Proposed Rebuild of the Libby (FEC) to Troy section of BPA's Libby to Bonners Ferry 115-kilovolt Transmission Line
"I'd like to tell you . . . "

JUN 01 2005 5/24/05
LTS-007

ATTACHMENT TO BPA PROPOSED REBUILD

STRUCTURE TYPES

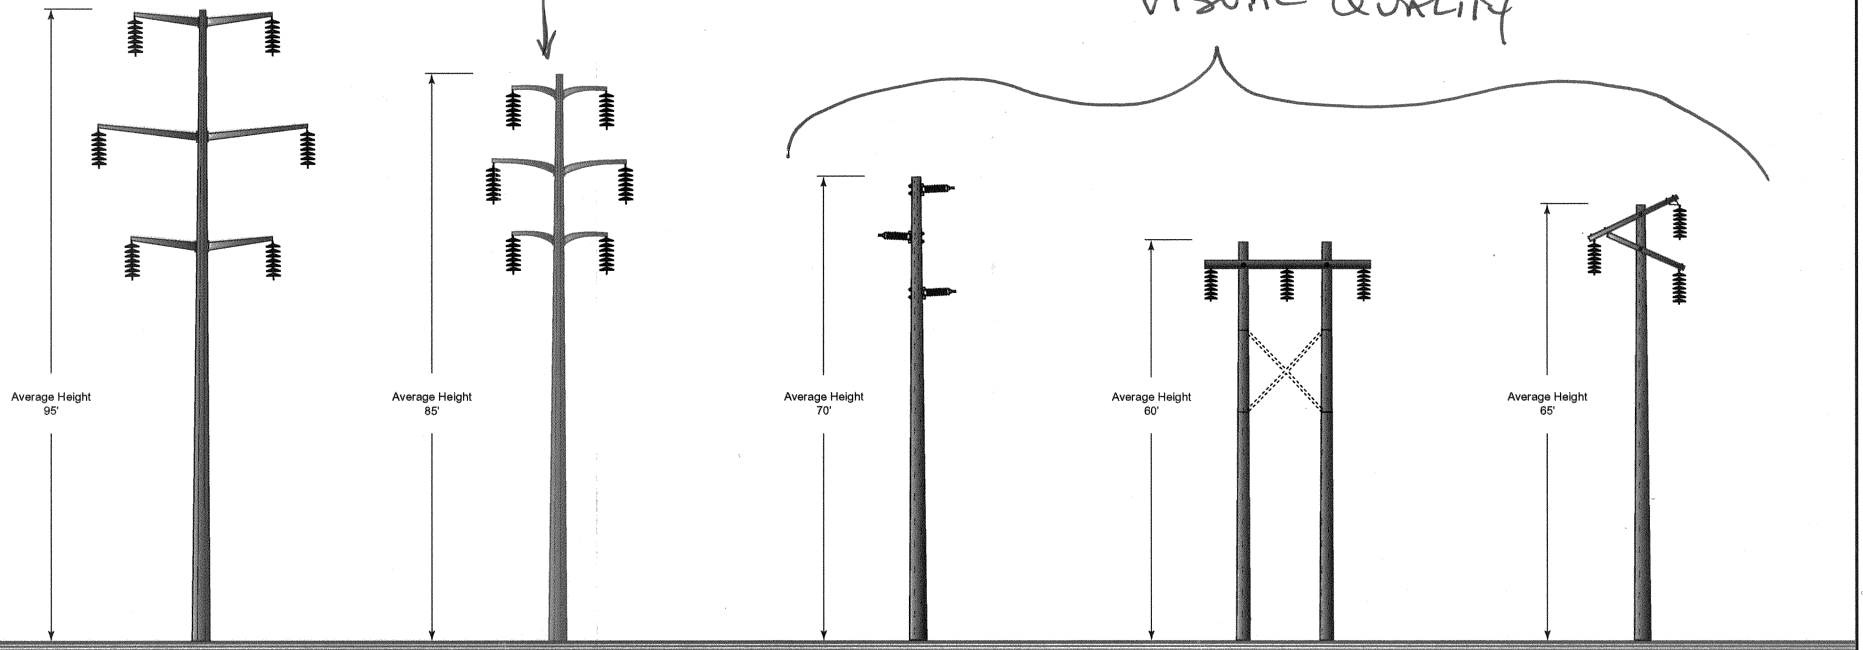
COMPROMISE

PLEASE USE THESE TYPE of STRUCTURES TO PROTECT VISUAL QUALITY

REBUILD OF THE LIBBY (FEC) TO TROY SECTION OF BPA's LIBBY TO BONNERS FERRY 115-KILOVOLT TRANSMISSION LINE

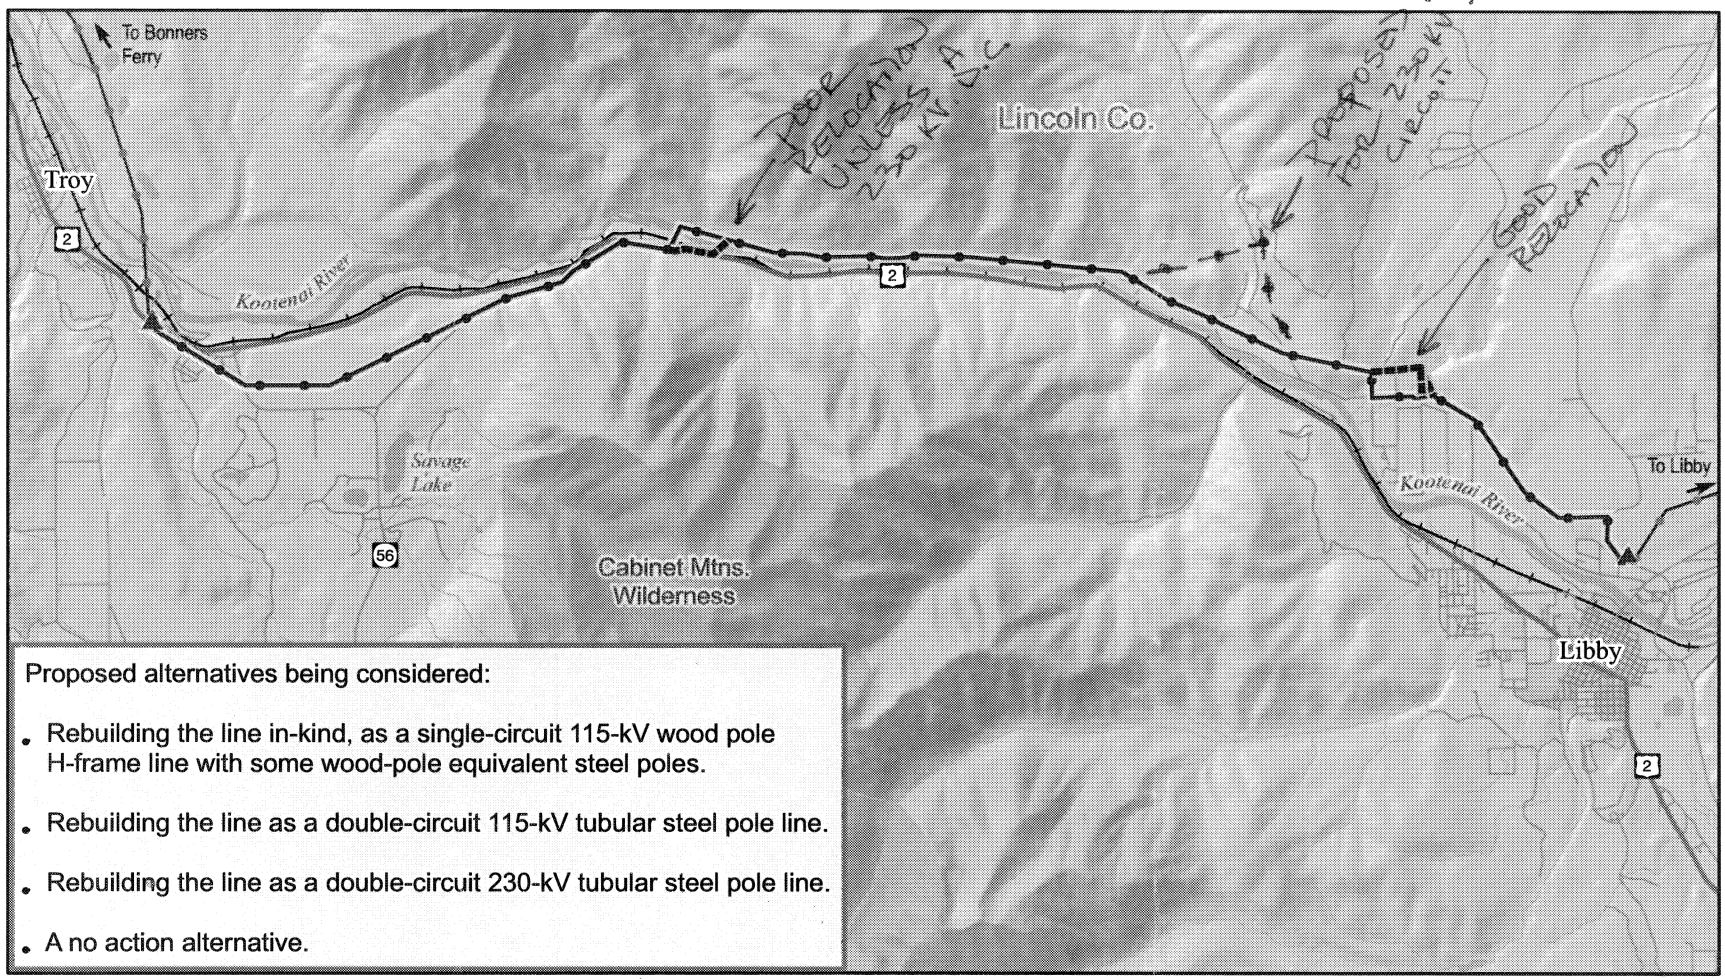
#4 IF YOU DO NOT ACCEPT MY RECOMMENDATION & INSIST ON PUTTING IN A 230 KV DOUBLE CIRCUIT LINE, I STRONGLY RECOMMEND THAT YOU PUT IN ANOTHER RELOCATION IN THE VICINITY OF LOWER QUARTZ CR. THAT WILL REMOVE THE POWERLINE FROM BIGHORN TERRACE (SEE ATTACHED MAP). A LARGER TOWER (95') & WIDER R/W (125') WILL DEVASTATE THE VISUAL QUALITY IN THAT AREA & REDUCE PROPERTY VALUES. IT WILL ALSO ANGER MANY PEOPLE.
